**Citizens of Ebey's Reserve (COER) Comments:  
Draft Environmental Impact Statement  
for Naval Air Station Whidbey Island  
Feb 10, 2018**

**Prepared by Robert Wilbur and CORE Board of Directors**

The following comments from Citizens of Ebey's Reserve (COER) on the Draft Environmental Impact Statement (DEIS) for Naval Air Station are submitted this day to EA-18G EIS Project Manager, Naval Facilities Engineering Command (NAVFAC) Atlantic – Attn: Code EV21/SS, 6506 Hampton Blvd., Norfolk, VA 23508.

## Grumman EA6B Prowler versus McDonald Douglas F18 Hornet and Growler

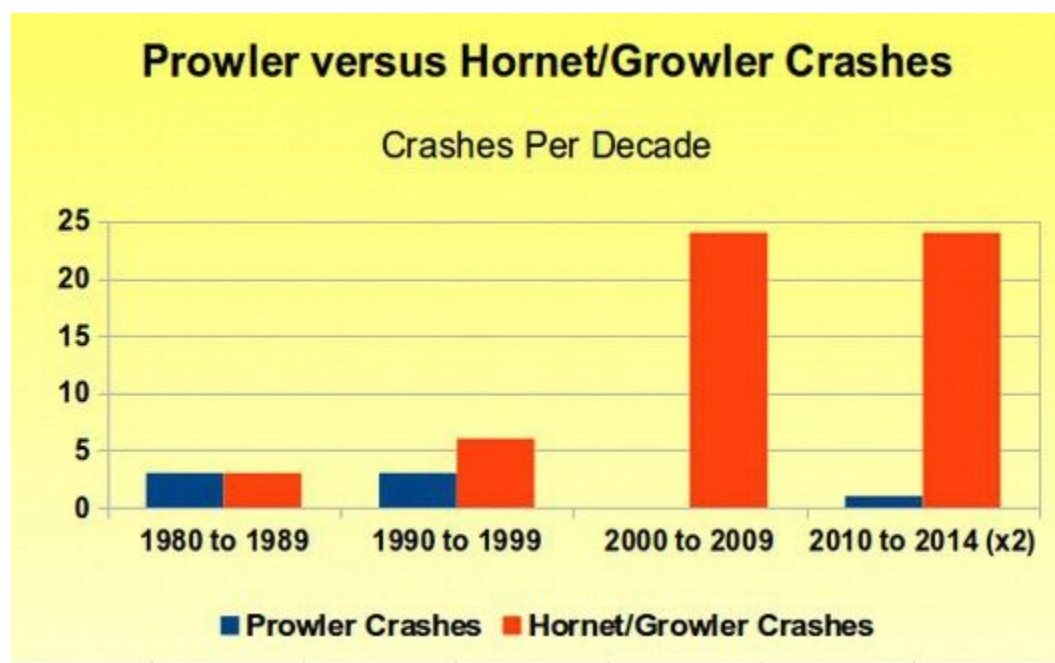
Another credible, independent analysis states, "Growler jets are much more difficult to fly and not made as well as the older Prowler jets," which is why their research found the Growler to be 10–36 times more likely to crash than the Prowler, as depicted in the tables and figure below <<https://washingtonenvironmentalprotectioncoalition.org/3-how-growler-jets-harm-people/3-2-growler-jets-36-times-more-likely-to-crash-than-prowler-jets>>.

**Last 35 years: 7 Prowler Jet Crashes and 45 F18 Hornet/Growlers Jet Crashes**

Figure 8.1 – Navy's schematic of Path 14 FCLP at OLFC. The AGL elevations are the about same for Path 32 (Source: <http://admiralscove.org/naswiolf.htm> ).

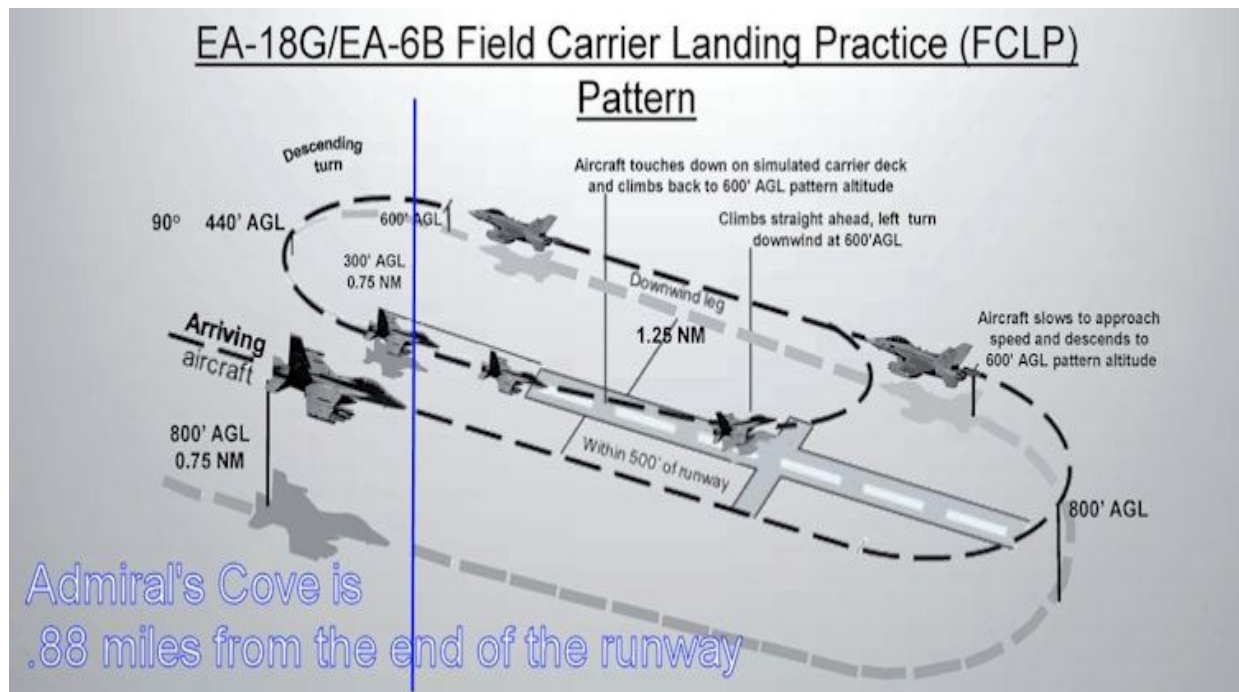
As shown in Figure 8.1 below, the approach to touchdown begins and descends from 400 feet, which puts it at about 400 to 200 feet over many residences within the “2000 foot radius of the aircraft.” Furthermore, the downwind leg of an FCLP at 600 feet above ground level (AGL) is not a takeoff or a landing approach but is an interim flight between touchdown and approach for another touchdown; nor is the arrival flight at 800 feet AGL a landing approach but is a circle of OLFC prior to beginning the first FCLP. So, no part of an FCLP at OLFC complies with the 1000 or 500 foot AGLs stipulated in the above FAA rule. Even if the approach and takeoff were to be accepted as “necessary for takeoff and landing,” and hence excluded, the downwind leg and arrivals are still noncompliant.

On approach to and departure from an OLFC touch-down, Growlers cannot comply with FAA rules and must cross over hundreds of residences, a well-used children's athletic field, dog park, county park trail system, a crowded recycle center, above ground fuel storage tanks, and a facility for 100 homeless teens.

**Conclusion:** The DEIS failed to consider and explain how it intends to operate at OLFC and Ault Field without violating very important components of federal law dealing with proximity rules to persons, vessels, vehicles, and structures, or conversely, explain how the Navy will appropriately compensate those impacted by takings.

However, compliance with Federal Aviation Regulation Part 91 was somehow overlooked in the DEIS and in Table 6-1. The DEIS must discuss and show how its FCLP activity is compliant with Part 91.
